STAFF REPORT

DATE: 03-19-19

TO: City Council
FROM: Ken Roberts – Planning Director
ITEM: **Bentley Village** – Zoning Map Amendment and Preliminary Plat
REVIEWED BY: Ben Prchal, City Planner
Jack Griffin, City Engineer

TYPICAL TOWNHOME LOT DETAIL

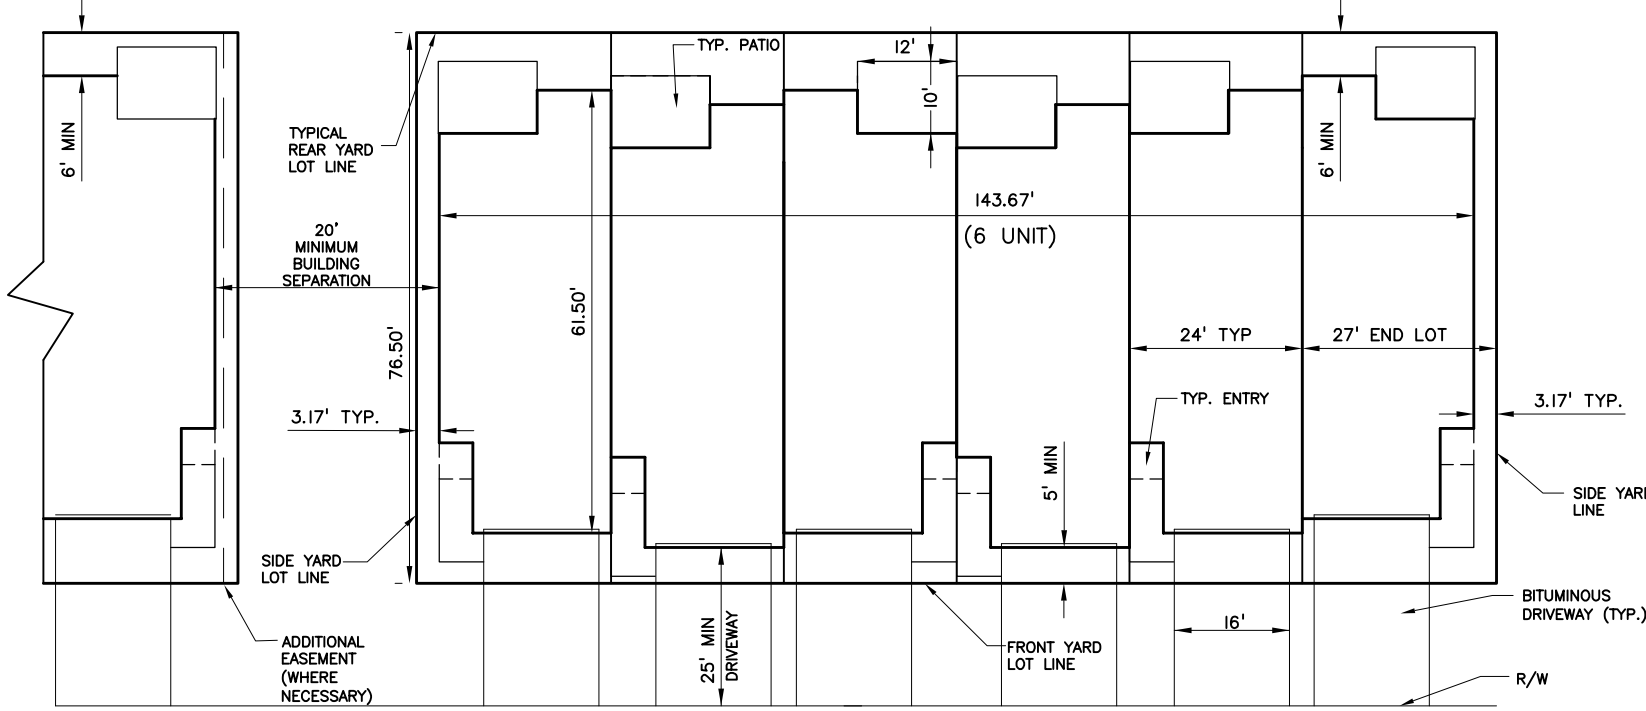
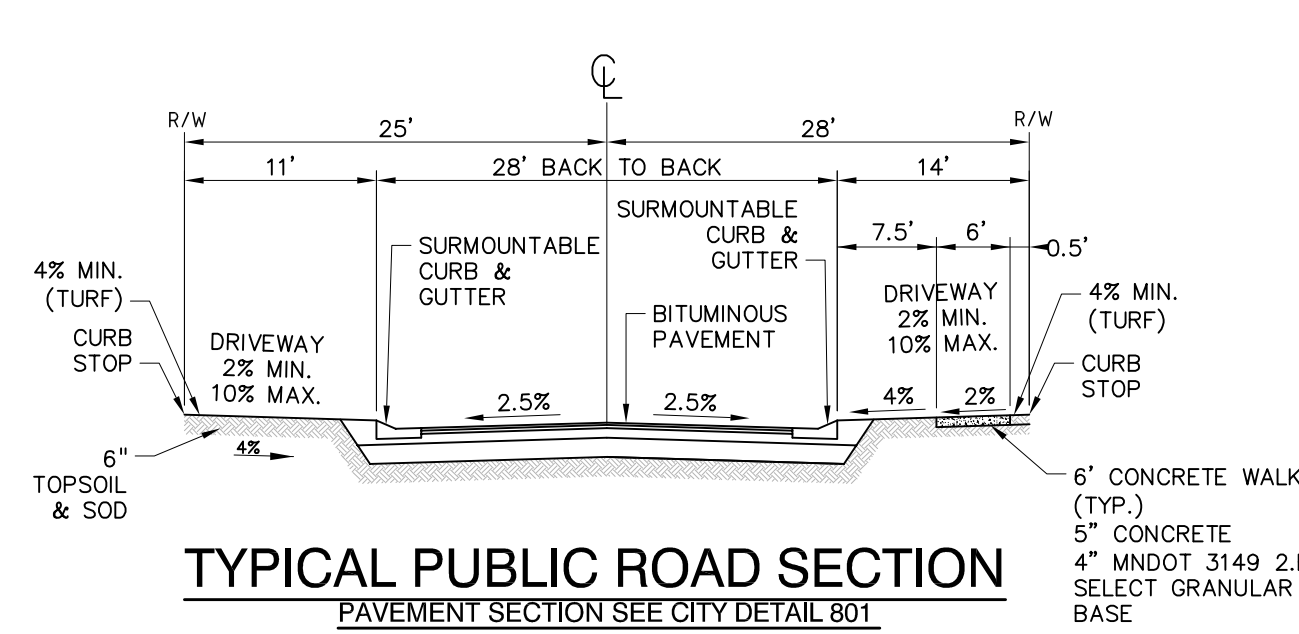
- Public Street Typical Sections. The preliminary plan typical sections must be updated to provide all required information consistent with City design standard details. The 10-foot utility corridors must be shown on each side for all public streets to be preserved for small utility installation. Driveway grades must be shown at 4% along boulevards, at 2% along the sidewalk, and can vary up to 10% once beyond

SHEET 7 of 33

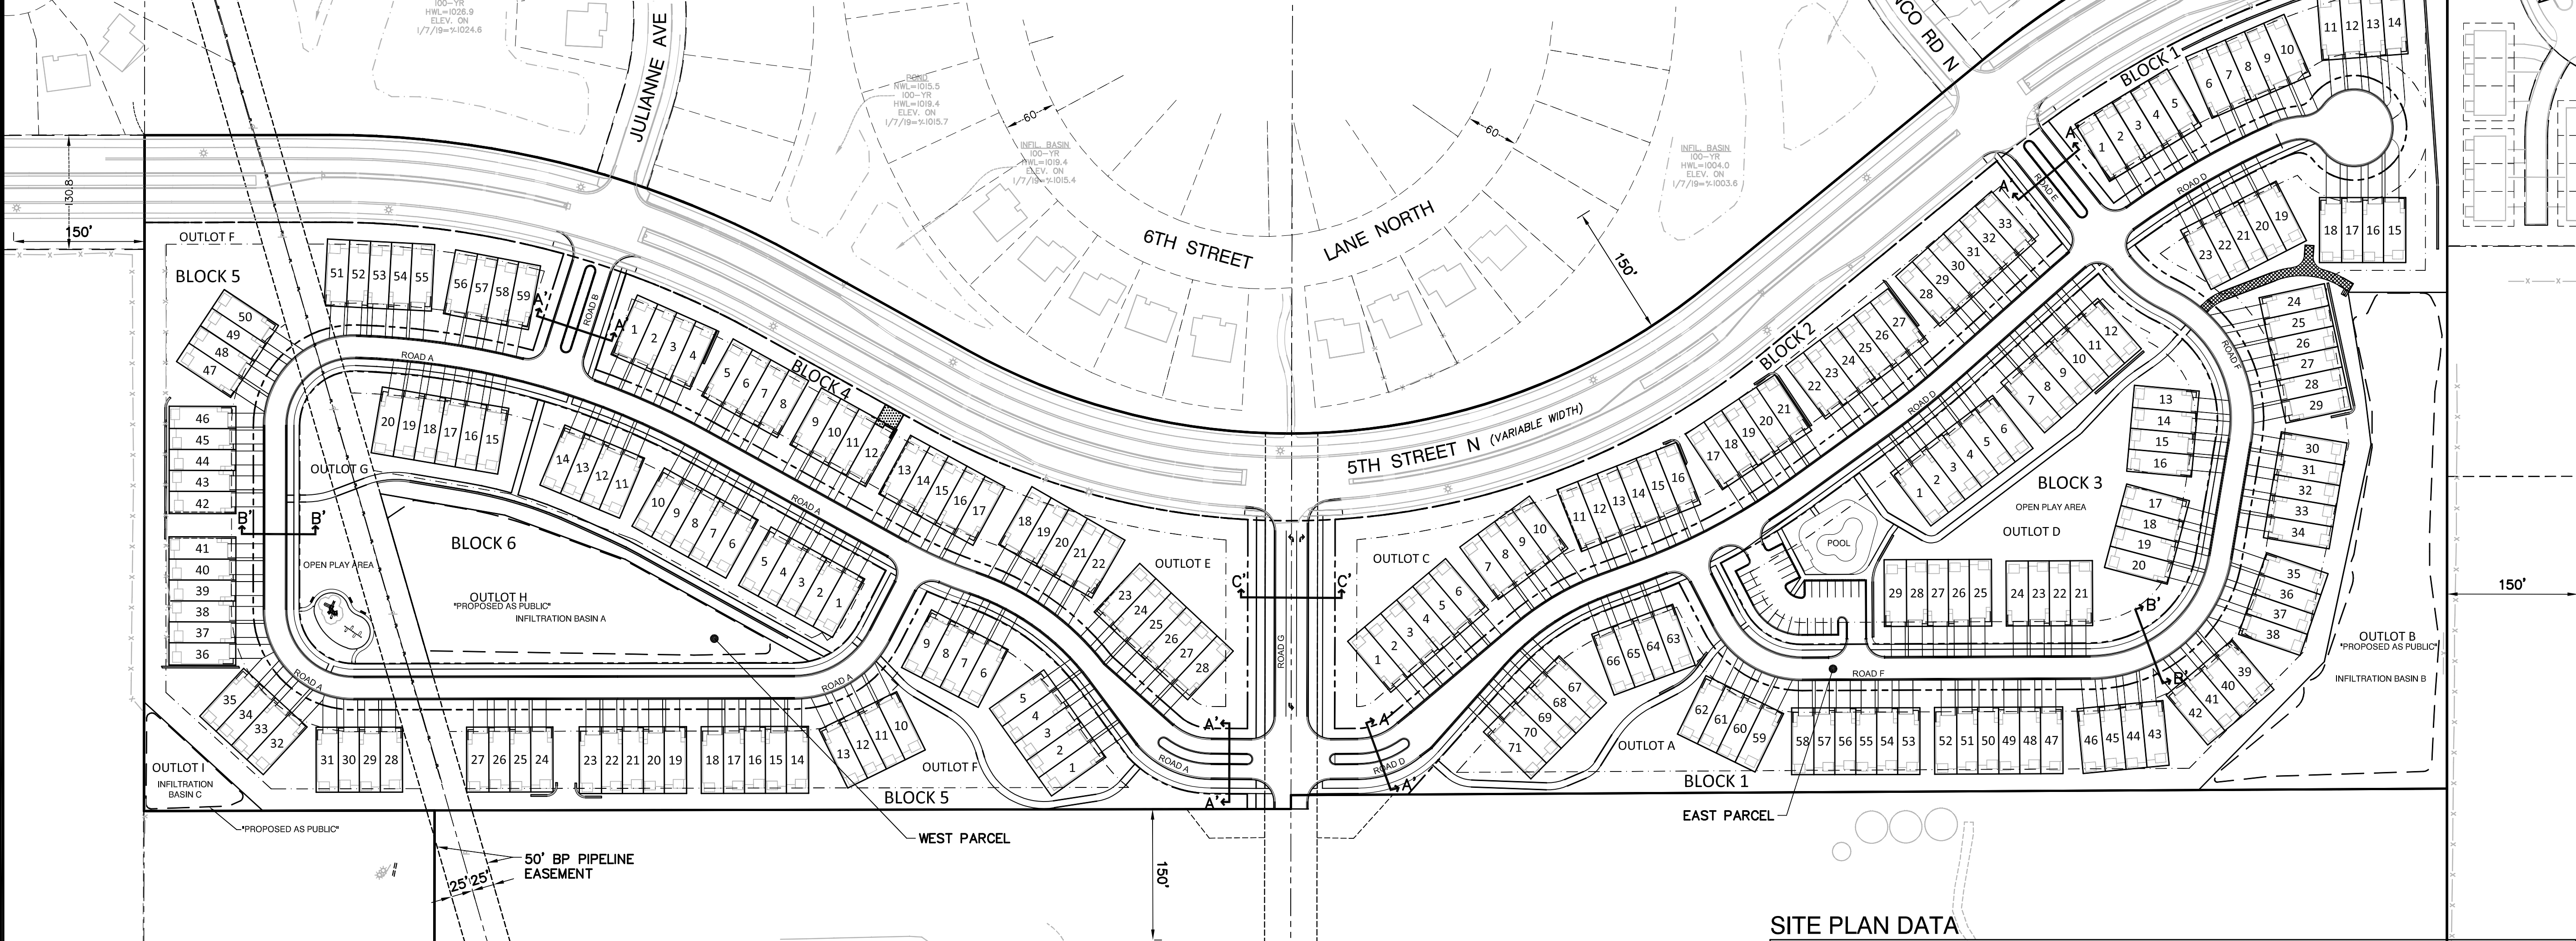
The original project plans the applicant submitted were not clear in showing that all of the proposed buildings and lots would meet all the required setbacks. Staff has included a detail from Sheet 7 of original the project plans that has a typical townhome lot layout showing the proposed lot lines and the building placement. However, staff has identified several locations on the original plans where it appears that corners of the proposed townhouses (or their patios) might encroach into required setbacks and/or easements or would be too close together to meet the City's 30-foot-spacing requirement to accommodate underground utilities (including storm sewer). These include:

Staff met with the developer after the Planning Commission meeting to further review the project plans in more detail. It now appears that all the structures, as shown on the original development plans, will meet all the required setbacks from property lines and rights-of-way. There are, however, some of the units on the original plans that would be set only 20 feet apart instead of 30 feet apart that the City Engineer requires when there is underground utilities running between the buildings. The developer has indicated to staff that they are revising the project plans to meet all City requirements for setbacks and building spacing. Staff is recommending the developer submit any and all revised project plans to staff that clearly show that all the units will meet all setback requirements and all spacing requirements for underground utilities.

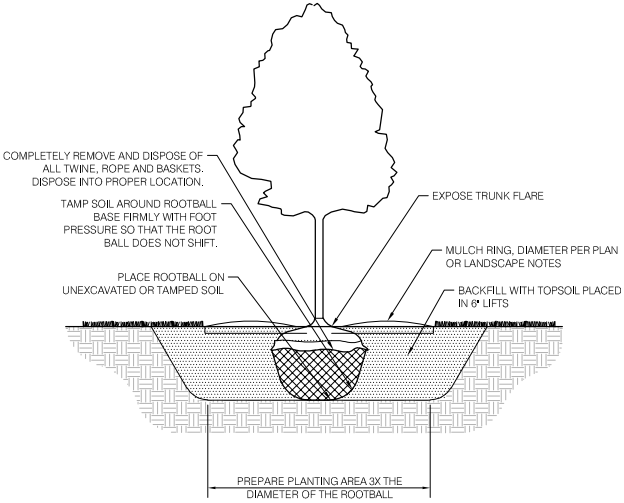
6. Utilities are not shown on the landscape plans to review for utility conflicts. Applicant should include that layer in the landscape drawings.
7. Topsoil depth is incorrectly labeled in the planting notes on sheet 33 as 4" minimum. City standard is 6" minimum. Applicant should update the note to the correct depth of 6".

8. Top soil depth is to be 6" and is called out correctly on cross-section drawings, however note 1 in the planting notes on sheet 33 states 4" of topsoil. Note needs to be updated.
